Wairoa District Council Wastewater Discharge

Annex A- Common Bundle of Attachments

Annex D – 1st S92 Request

Annex E – 1st s92 Response

AEE Figure 5.1: Main WWTTP Outfall Relocation Area with Proposed Outfall (June 2019) Overlaid

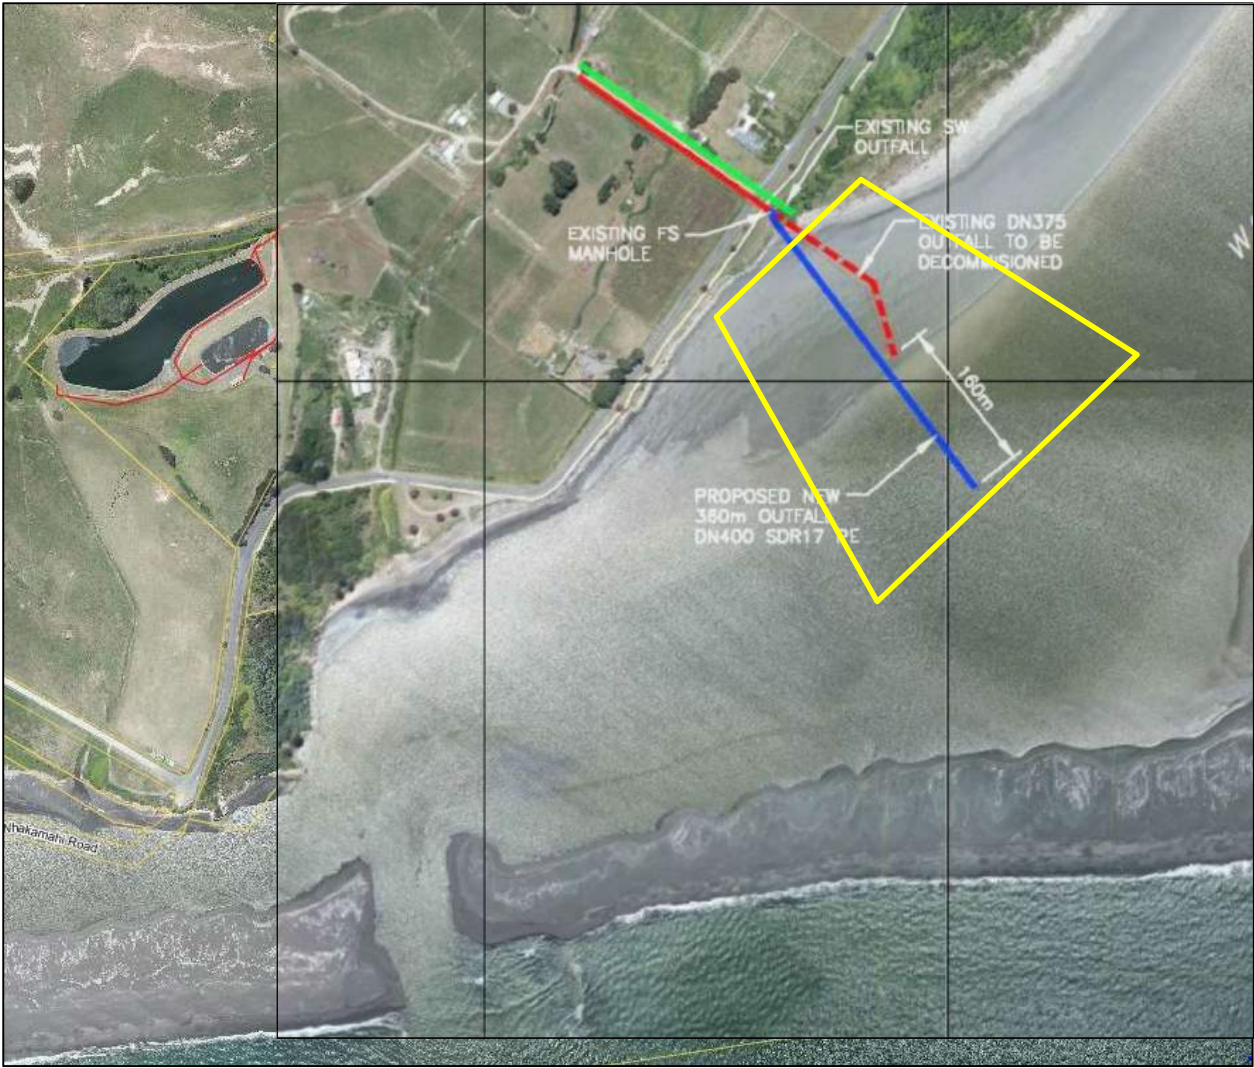
- The report states that the main outfall pipe is proposed to be relocated within the Outfall Relocation Area as indicated in Figure 5.1 of the consent application. Drawing DR-190504-001[1] details the outfall pipe being buried, anchored by concrete and looks rigid. If a location change is required, will the existing pipeline be abandoned or will all infrastructure be excavated and relocated?

Figure 5.1 of the AEE provided a broad area (yellow outline) within which the outfall pipeline could be relocated; this area was deliberately made large enough to cover all possible river channel migrations and to provide freedom for designing the pipeline configurations. In the event that the new outfall requires relocation in future, there are various options available for achieving this. The pipeline could be shortened or extended without changing its alignment, a bend could be inserted at an appropriate point to create a dog-leg for the final section (similar to that of the current outfall pipeline), or the full length of straight pipeline could be rotated to a different angle from its currently proposed alignment.
